ADDENDUM No. 1

PROJECT: BSA Hospital PET/CT Infill
1600 Wallace Blvd.
Amarillo, TX 79106

DATE: 03/07/2025
PROJECT NO.: 22418

SHEET NO.
CR2
 2 OF 2

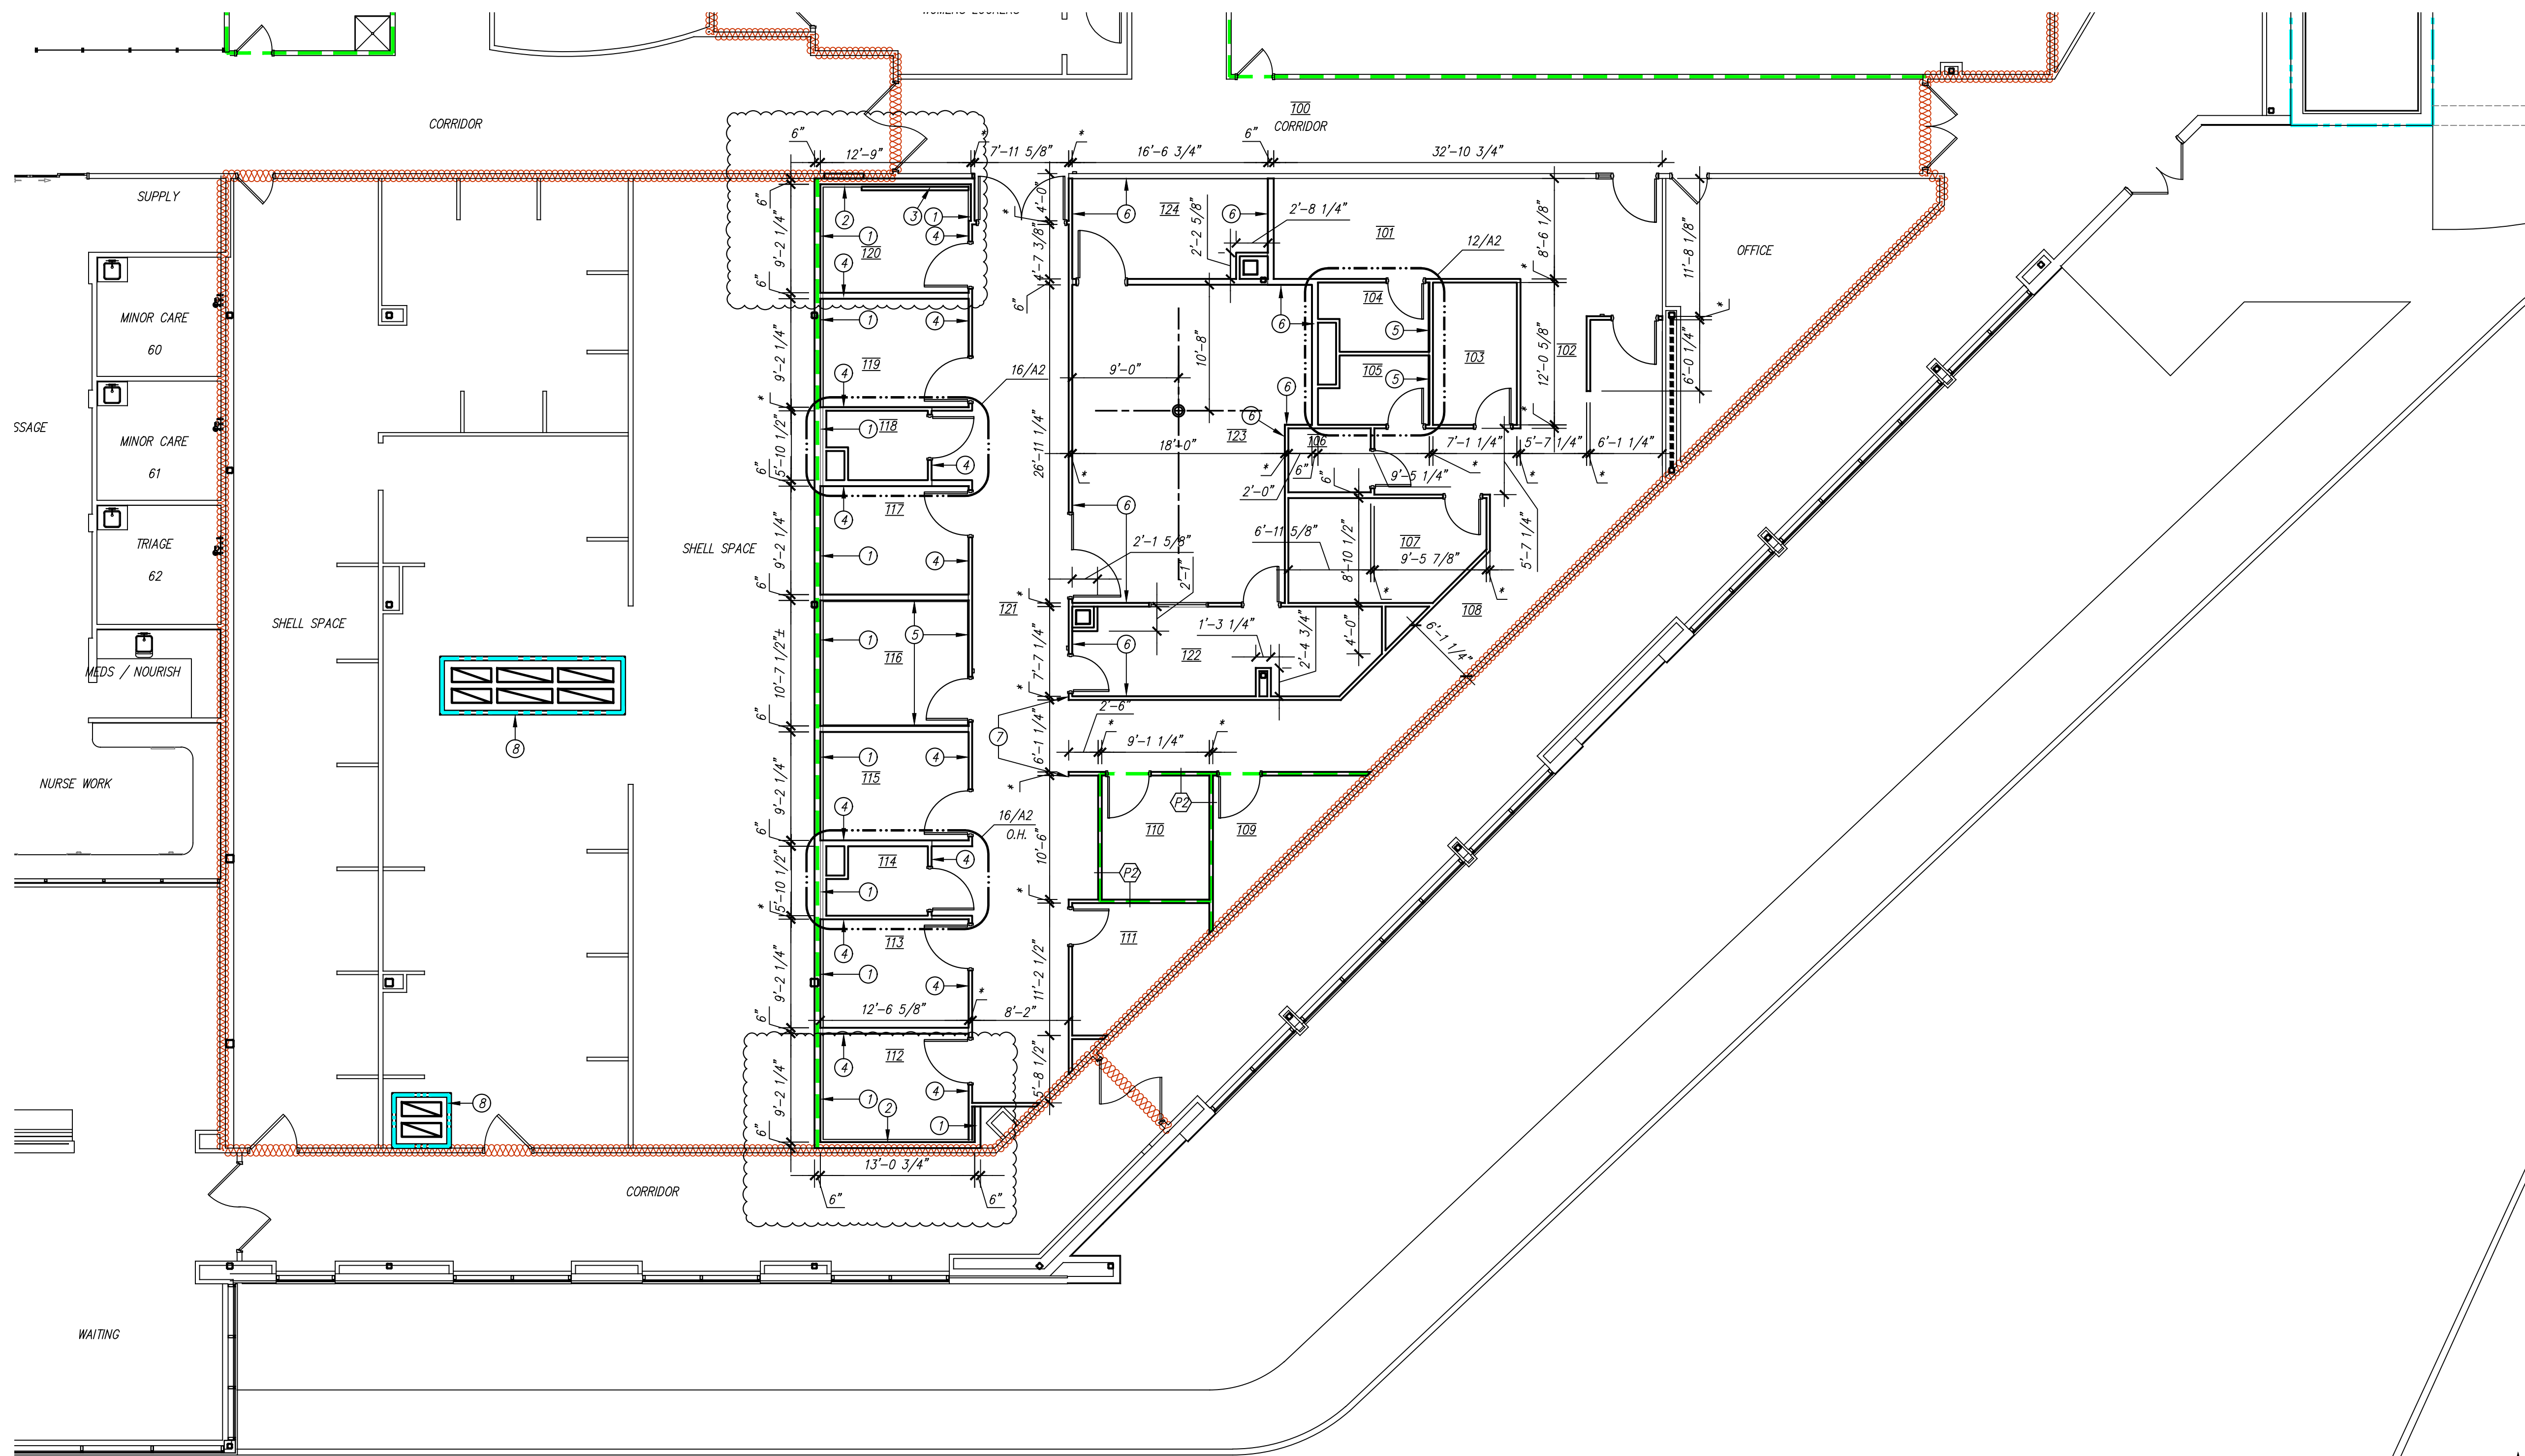
ITEM #9: Revised Drawings – Refer to the attached, revised sheets CR2, A2, A3, A6 & A8. These sheets are to be incorporated into the Contract Documents and take the place of previously issued versions.

27/A2 DIMENSION PLAN
SCALE: 1/8" = 1'-0"

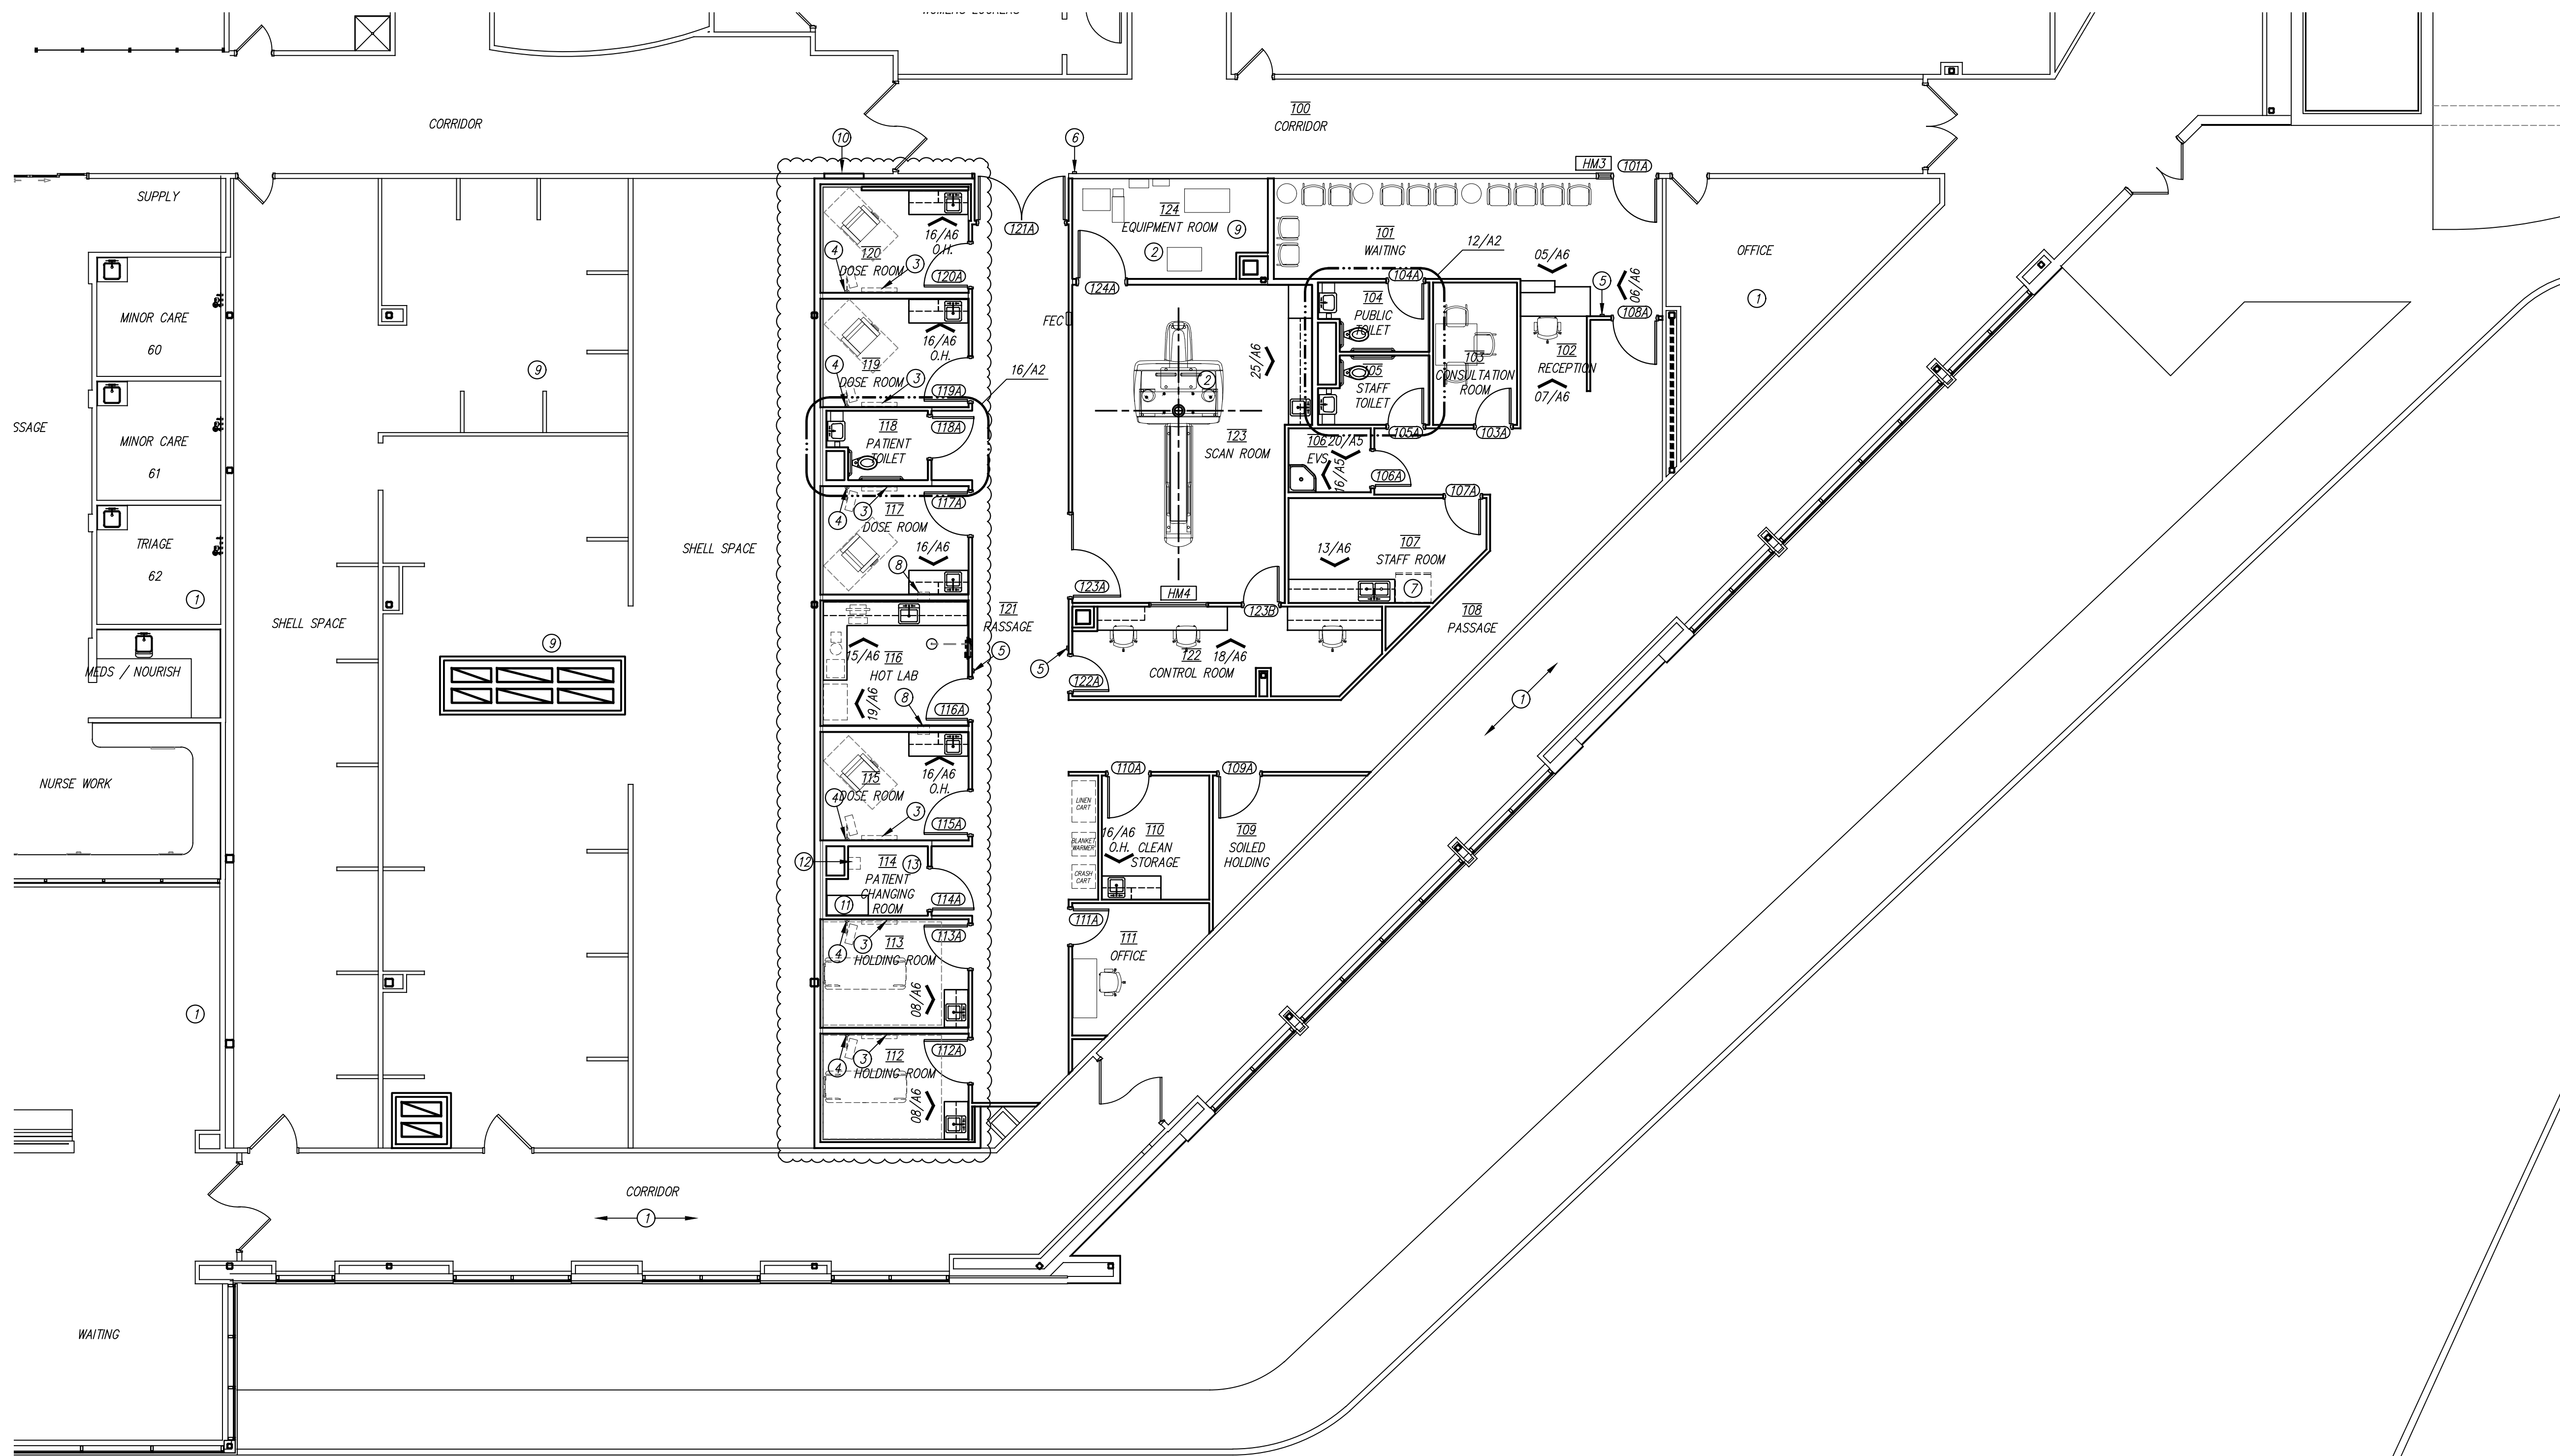
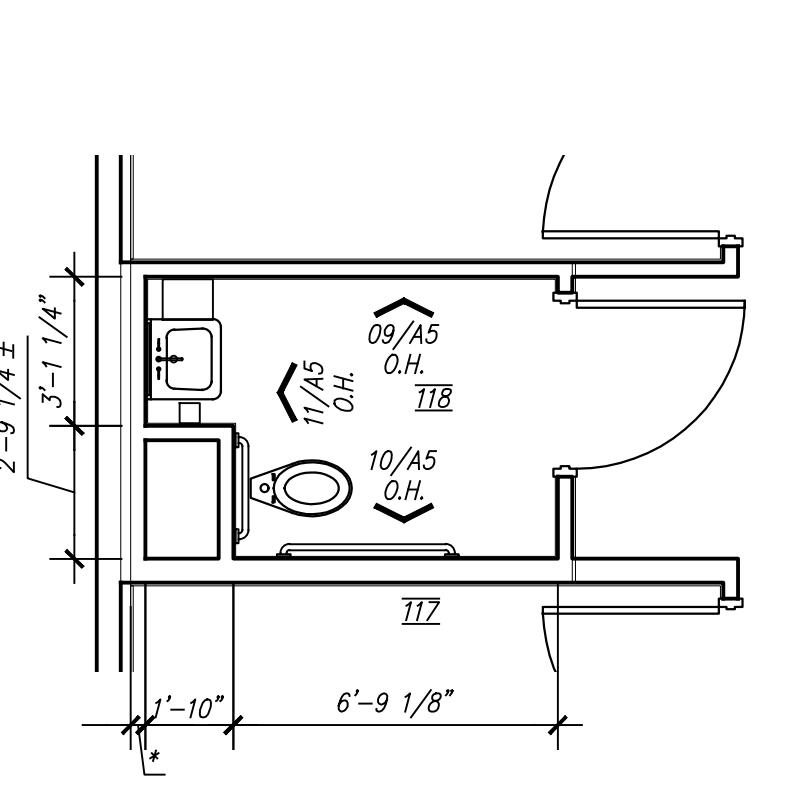
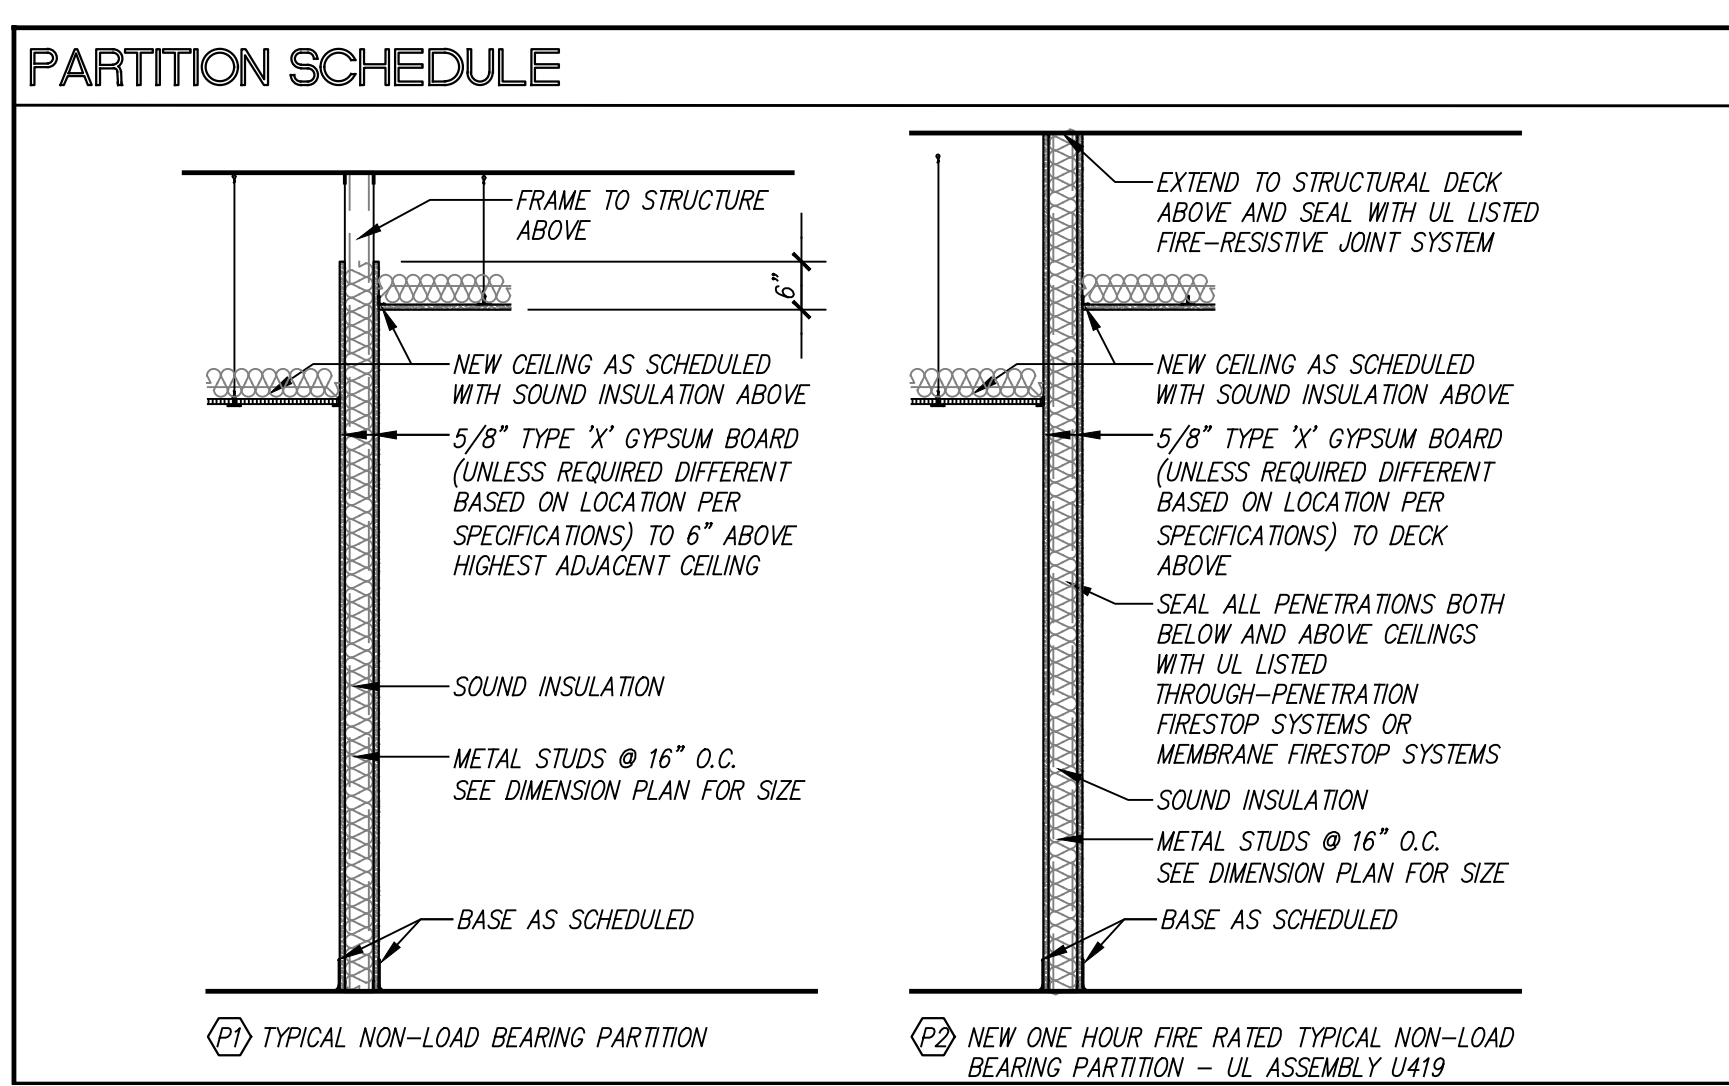
ITEM #4: Lead Shielding – To clarify, lead shielding on the walls is only required to extend to 7'-0" per the physicist's report. It is noted in the drawings to extend the 1" thick shielding around the dosing rooms to 8'-0", but that was based on our understanding that plywood lead shielding came in standard 4'x8' sheets. It would be permissible to install that shielding to 7'-0" and furrout above this if it is more economical. Additionally, the design team would be open to other methods of providing the 1" lead shielding along these walls (lead-bricks) as long as the Contractor takes all responsibility for that lead shielding design ensuring that it meets all the same criteria of what is in the Contract Documents. This would include at a minimum, providing the 1-hour rating where required, the overall thickness of the wall and location of the wall does not change, the Contractor would take all responsibility for providing Sealed Engineered Drawings for a delegated design, and the overall design intent does not change. This would need to be submitted as a Substitution Request. Engineered Drawings would not be required for the initial substitution request but would be required to be provided during the submittal phase.

- THIS WALL TO RECEIVE (2) LAYERS OF 3/4" LEAD-LINED PLYWOOD WITH 1/2" LEAD SHEET (1" TOTAL LEAD) ON THE ROOM SIDE OF THE WALL UP TO 8'-0" A.F.F. RUN LEAD LINING CONTINUOUSLY WHERE PERPENDICULAR WALLS ABUT. ABOVE 8'-0", INSTALL 2 1/2" FURRING STUDS. INSTALL 3 5/8" FURROUT WALL IN FRONT OF LEAD-LINED WALL FOR PLUMBING CHASE. INSTALL 5/8" GYPSUM BOARD ON NEW OUTSIDE FACE OF THE WALL. REFER TO STRUCTURAL FOR WALL FRAMING.
